**National Fish and Wildlife Foundation
Closure Memo**

Project: Green Infrastructure at Mamaroneck Town Center to Improve Water Quality in Long Island Sound (NY)
Number: 1401.15.049098
Grantee: Town of Mamaroneck

ADDENDUM TO THE FINAL PROGRAM REPORT

49098 Green Infrastructure at Mamaroneck Town Center to Improve Water Quality in Long Island Sound (NY), Town of Mamaroneck

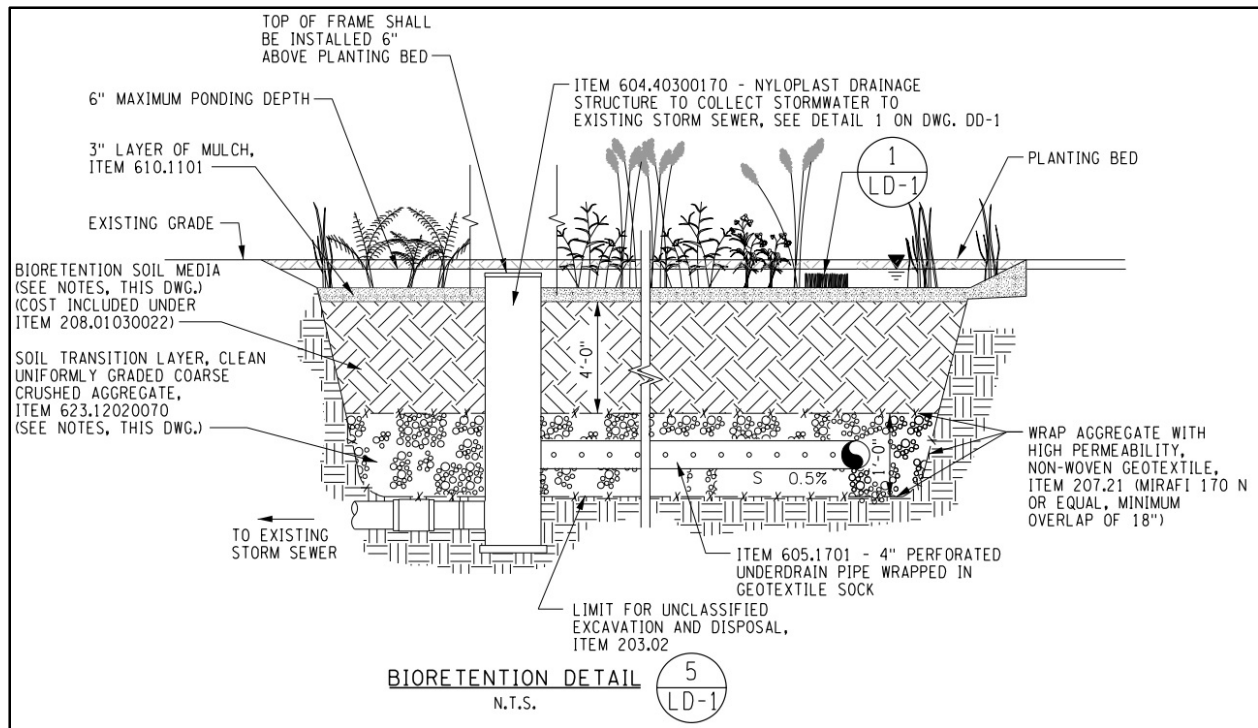
- Porous asphalt was installed in the vehicle parking area. How much (sq. ft.) of porous asphalt was installed? Approximately 2,200 square feet of porous asphalt pavement was installed on site. The porous asphalt was installed only in an area that had the greatest possibility of success, specifically, it was not on a steep grade and would not be exposed to heavy leaf litter.
- Porous pavers installed? How much (sq. ft.) of porous pavers was installed? Where were these pavers installed? Were they installed as pedestrian sidewalks? If not, discuss why sidewalks were not installed? Approximately 4,950 square feet of porous pavers were installed around the site. The specific product used is PaveDrain (<http://www.pavedrain.com/>) and it was installed around the north, west, and east

sides of the building. A few pictures have been shown below which show the product installed.

The porous pavers replaced the existing concrete sidewalk and asphalt walkways that were around the building. No porous pavers were installed in locations where detectable warning units were placed. Concrete panels were installed around the detectable warning units for easier installation and long term durability. The overall area of pedestrian walkway was reduced (still a 5 ft. minimum though) but access to all existing entrances and exits were maintained.

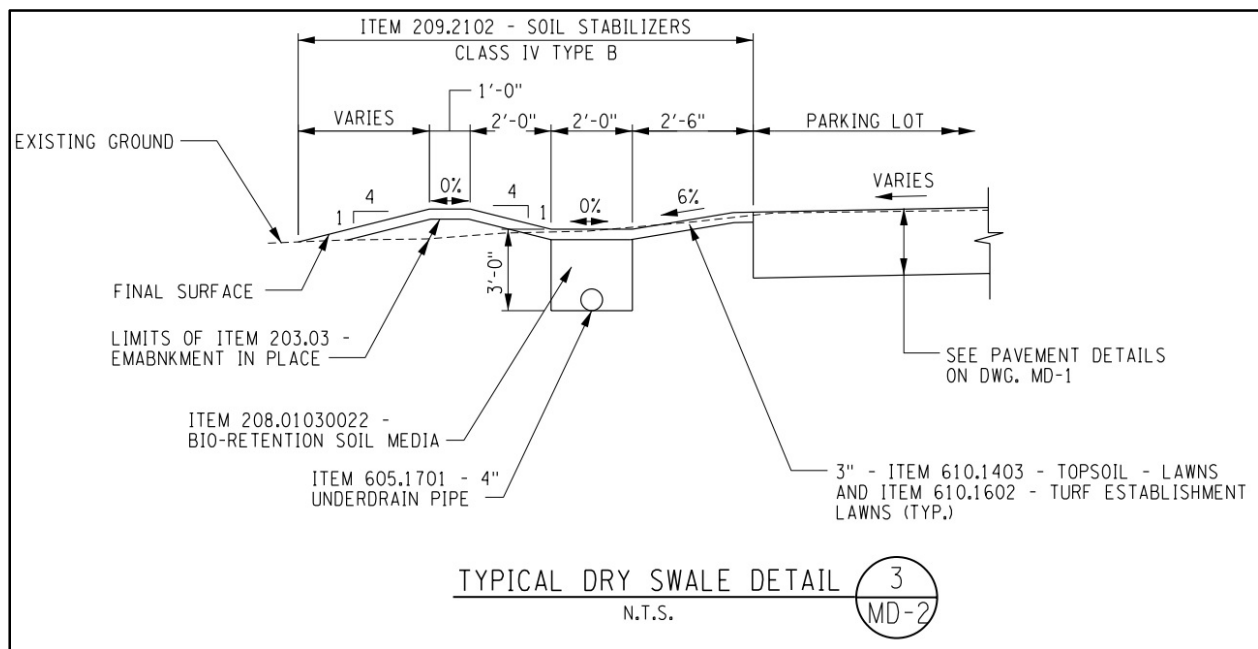
Approximately 585 square feet of rain garden has been installed. The plants installed are as follows: Serviceberry, Dwarf Fountain Grass, Purple Dome Aster, Double Purple Coneflower, Happy Returns Daylily, Sweet William Dianthus, Isanti Red Twig Dogwood, Gro-Low Fragrant Sumac.
- One dry swale was installed. How much (sq. ft.) of dry swale was installed? Describe in more detail what is meant by a dry swale? What is its purpose?

Approximately 115 ft. of dry swale was installed. The dry swale accepts concentrated curb stormwater flow on the upstream side and connects to a rain garden on the downstream side. The dry swale acts as pretreatment for the rain garden. The approximate area of dry swale is 330 square feet. The detail below show the dry swale.
